UNITED STATES
DEPARTMENT OF THE INTERIOR
BUREAU OF LAND MANAGEMENTFORM APPROVED
OMB NO. 1004-0135
Expires: November 30, 2000**SUNDRY NOTICES AND REPORTS ON WELLS**
*Do not use this form for proposals to drill or to re-enter an abandoned well. Use form 3160-3 (APD) for such proposals.***SUBMIT IN TRIPLICATE - Other instructions on reverse side.**

XTO Energy Inc. proposes to plug & abandon this well per attached procedure.

Murphy D #2- Aztec Pictured Cliffs

PLUG AND ABANDONMENT PROCEDURE

Proposed P&A

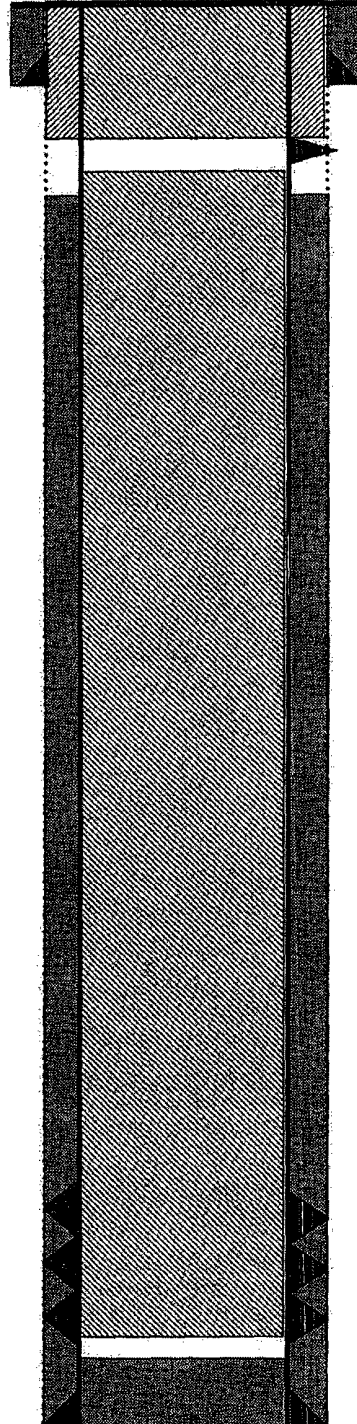
3. ⁸³⁰
Plug #1 (Pictured Cliffs perforations and Fruitland, Kirtland, Ojo Alamo tops, 2417' - ~~850'~~): Mix and pump 60 sxs Type III cement (long plug, 30% excess) and bullhead the down 2.875" casing: first pump 10 sxs cement, then drop 5 RCN balls, then pump 50 sxs cement to fill the casing to the perforations, displace to 300'. Double valve the wellhead and shut in well. WOC. Tag cement with wireline; TOC should be 850' or higher.

Plug #1: 2417' - 850'
Type III cement, 60 sxs
